SUBJECT: NEW VEHICLE DEMONSTRATION / DELIVERY HOLD
Safety Recall 20S56
Certain 2019 Model Year Super Duty Vehicles
Dana Axle Tube Weld

CERTAIN 2019 MODEL YEAR F-SUPER DUTY VEHICLES — DANA AXLE TUBE WELD

FIGURE 1

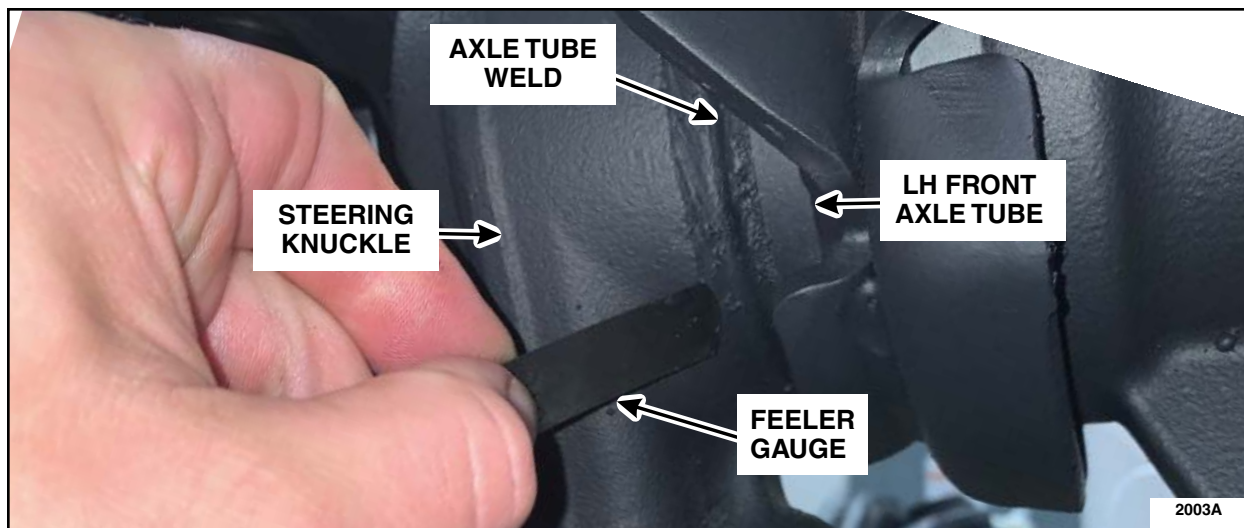
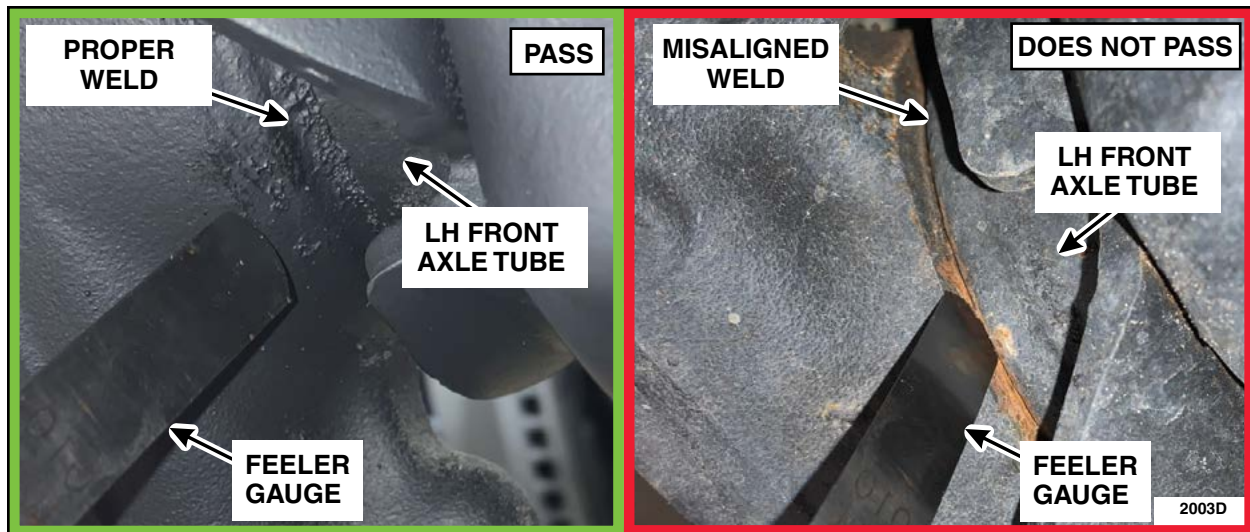
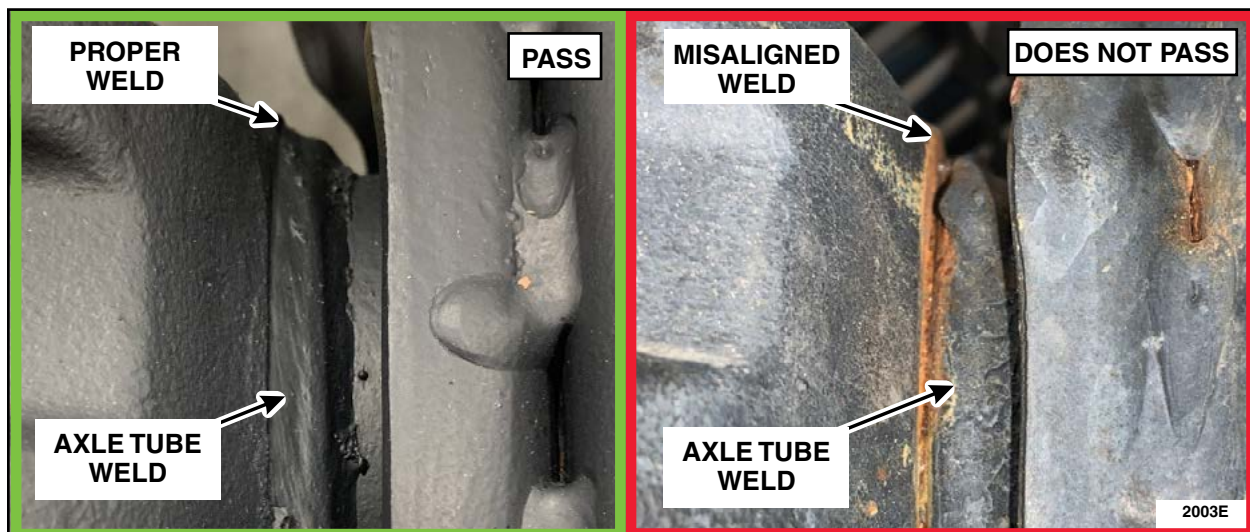
1. Position the vehicle on a hoist. Please follow the Workshop Manual (WSM) procedure in Section 100-02.
2. Remove the LH (Left Hand) front wheel and tire assembly. Please follow the WSM procedure in Section 204-04.
3. Inspect the LH front axle tube to steering knuckle weld. Can you fit a 0.010" feeler gauge between any portion of the weld and the steering knuckle, inspecting in four locations around the axle weld? See Figures 1, 2 and 3.

No - Passes Inspection, reinstall the wheel and tire assemblies. Please follow the WSM procedure in Section 204-04. Procedure is complete.

Yes - Does not pass inspection, proceed to Step 4.

4. Open the driver's side front door. Take a picture of the Vehicle Identification Number (VIN) sticker on the lower-A-pillar, and two pictures of the suspect weld at two different locations. Submit the pictures to the Special Service Support Center (SSSC) for further review, and repair direction if necessary.
